# STERLING RANCH ROAD & BRIARGATE PARKWAY STORM PLANS

COUNTY OF EL PASO, STATE OF COLORADO  
STORM SEWER PLANS  
MAY 2022

# ENG-CDR22001-R3-CDs Storm.pdf Markup Summary

TEMPORARY POND FSD16 WQCV TRASH RACK AND PLATE DETAIL (PLAN)

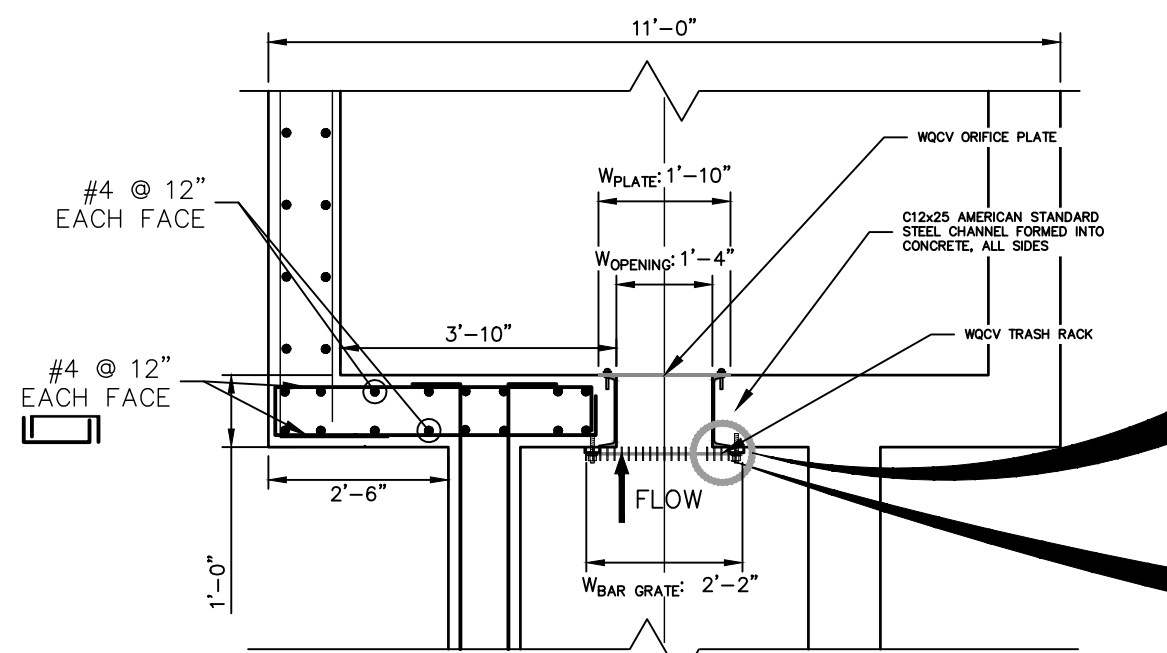
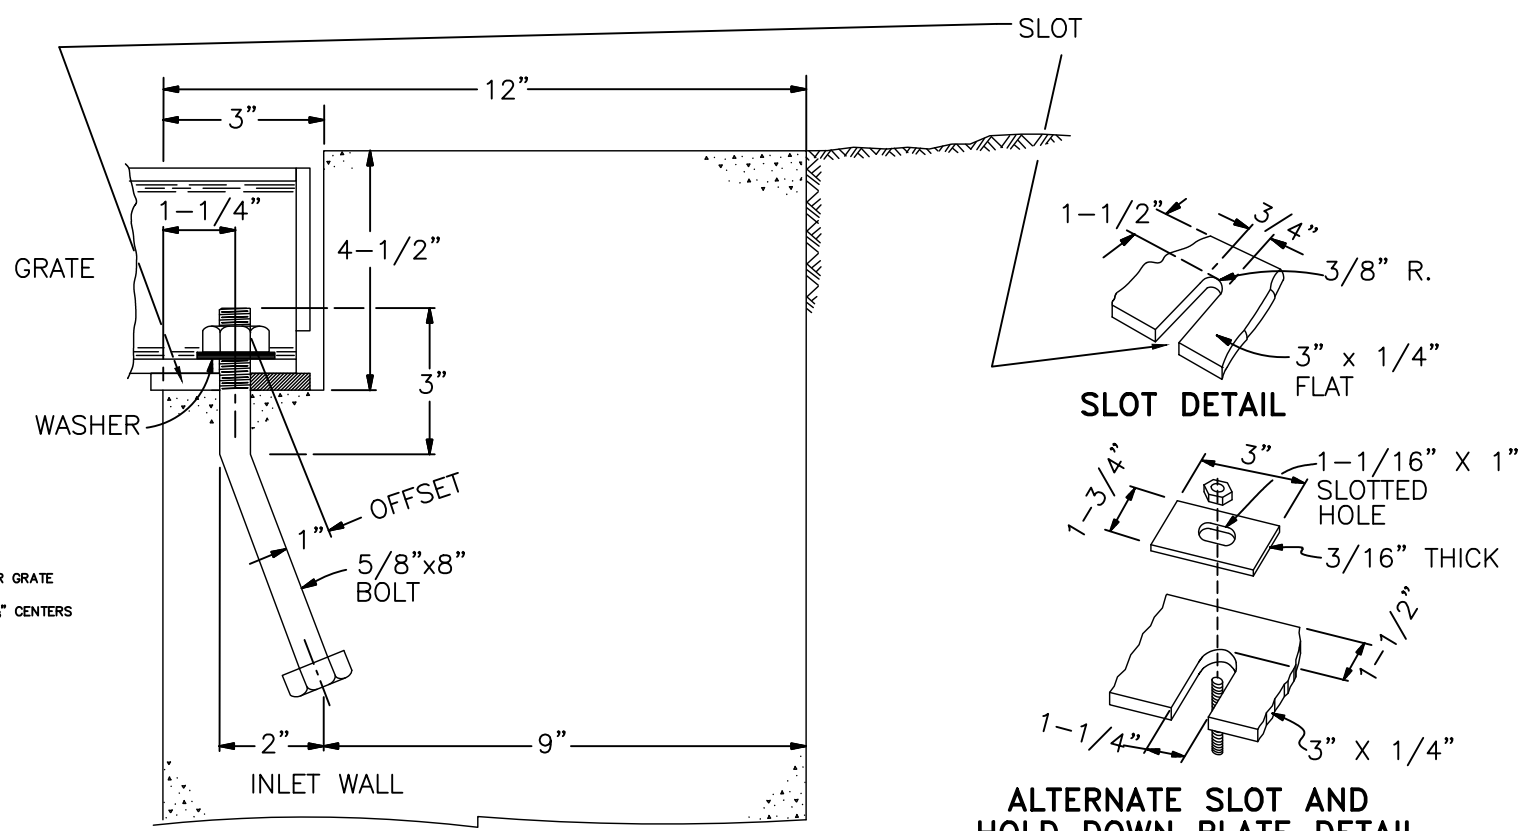
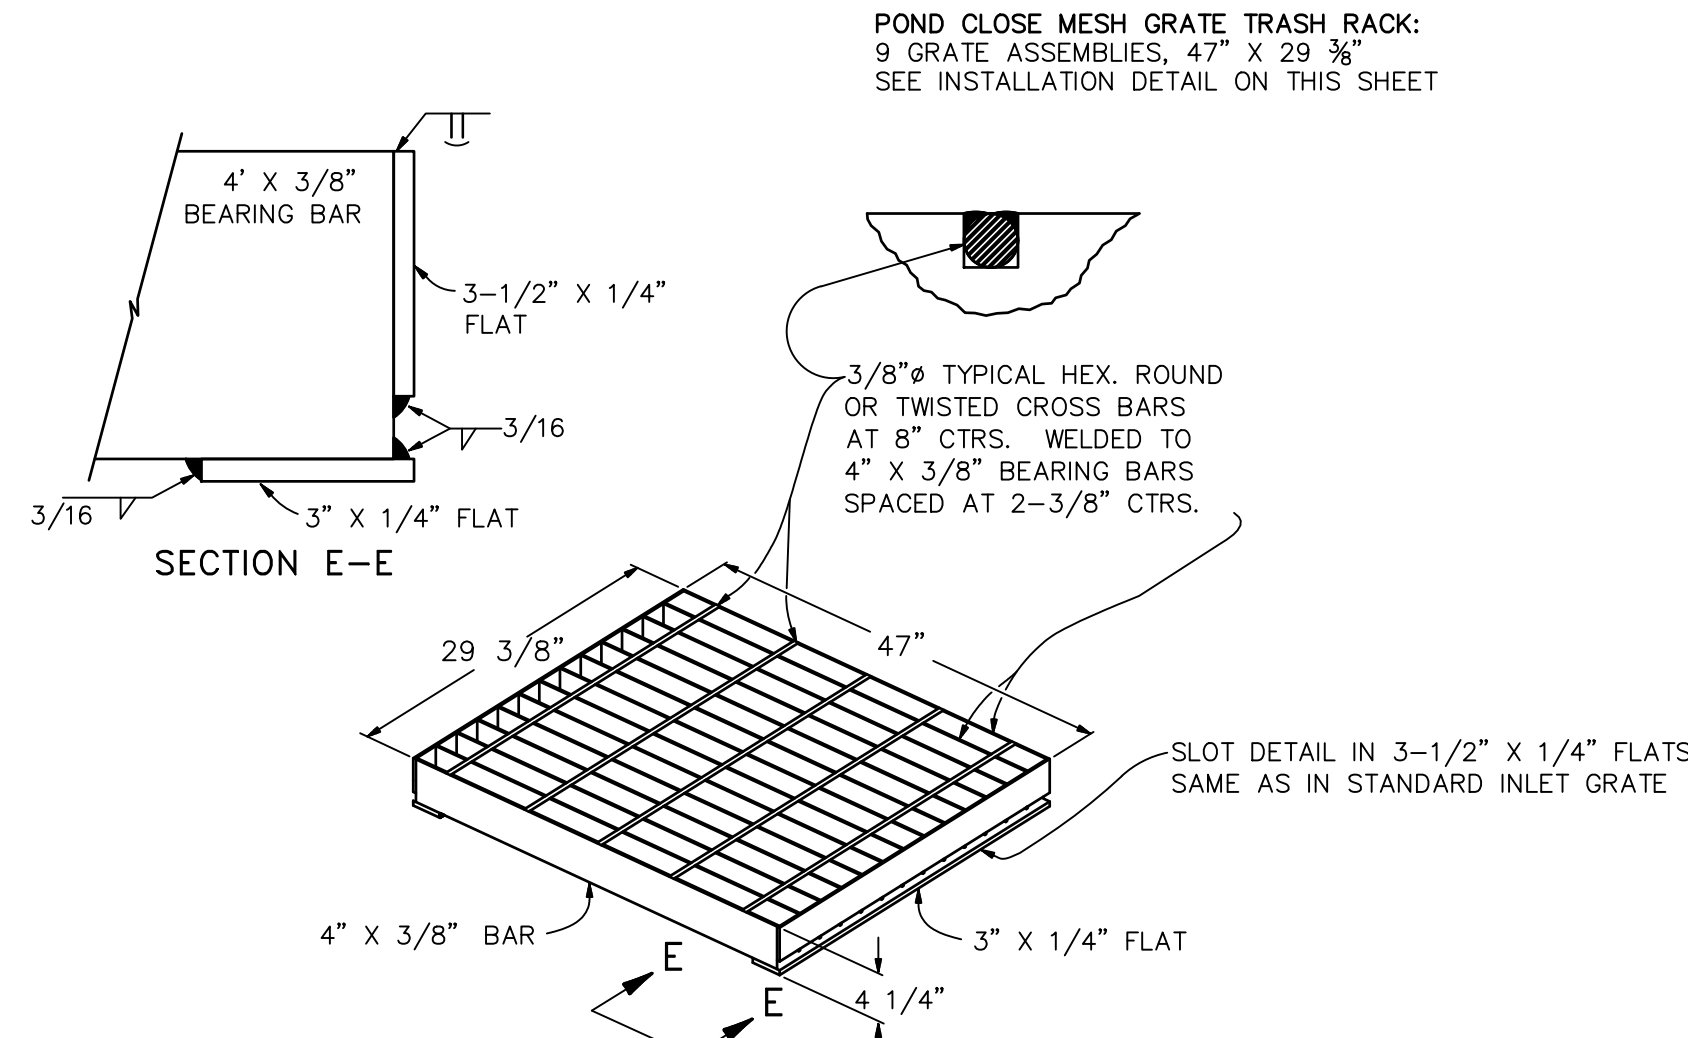
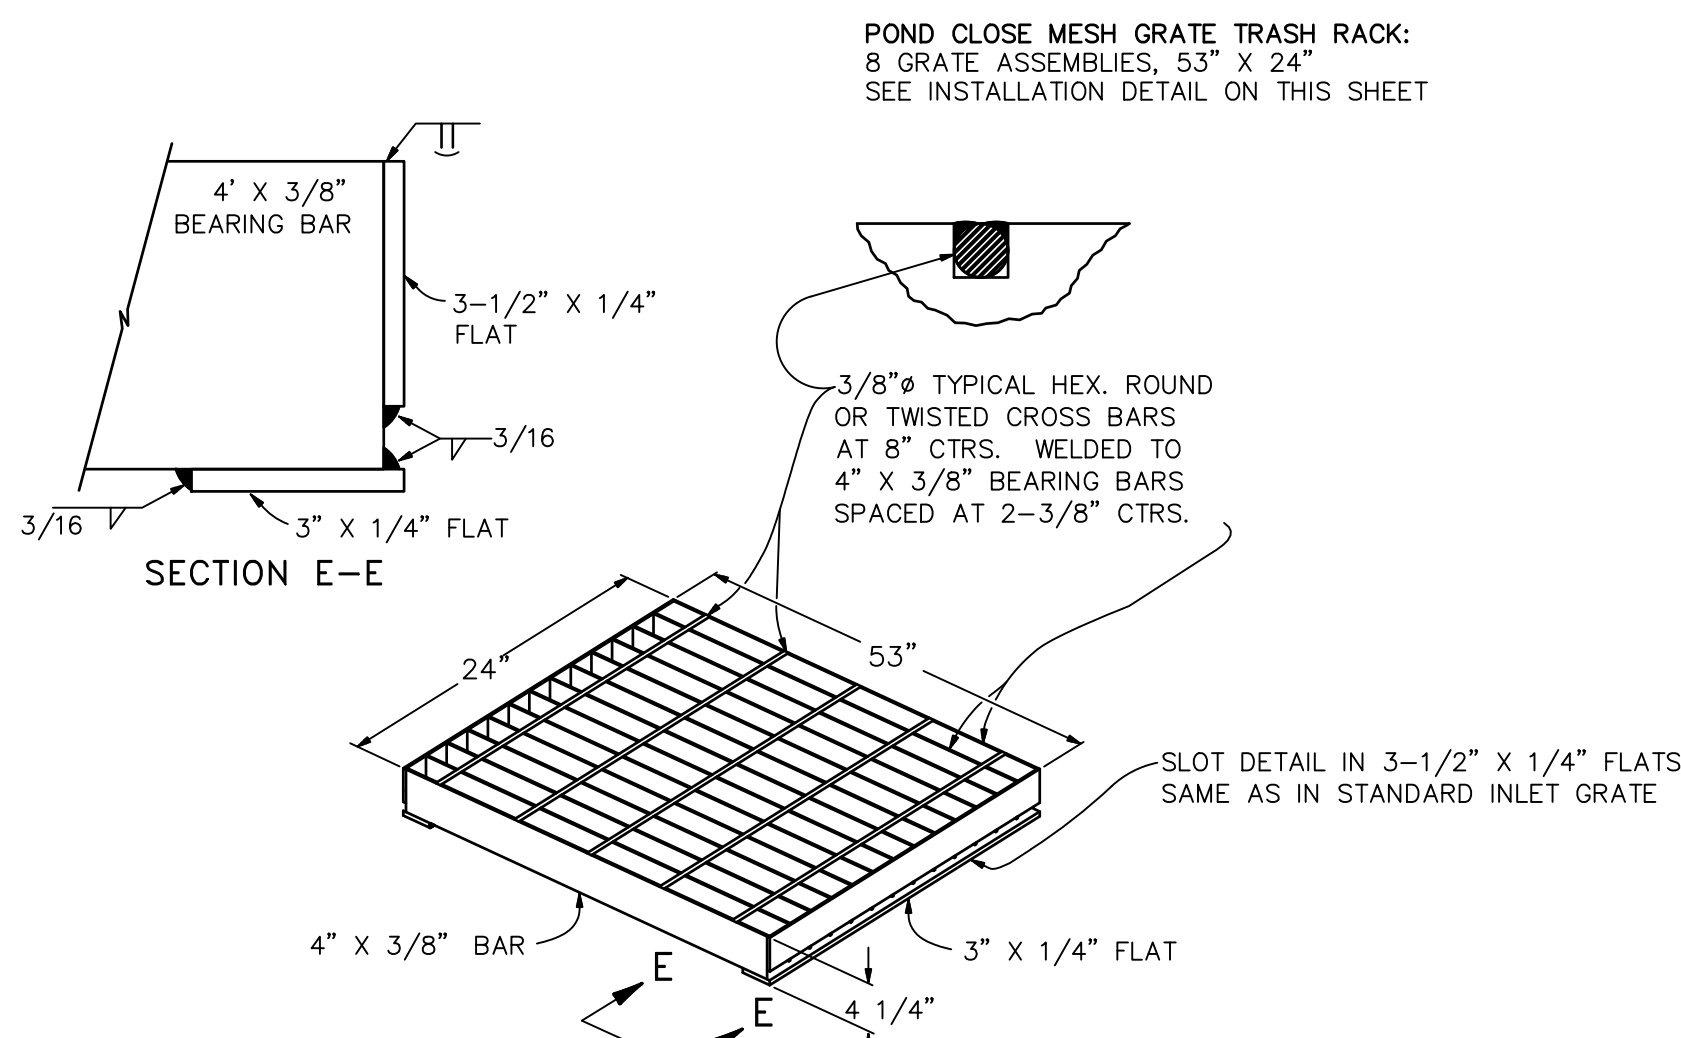
Per meeting with engineer Mike Bramlett on 4/11/2022, we discussed that for this project, only a TSB will be constructed. The subsequent EDB and all associated structures (trickle channel, forebay, outlet structure, etc) will be built with a near-future adjacent project.

So Mike is going to mark this drawing "For Information Only" or remove it from the drawing set entirely.
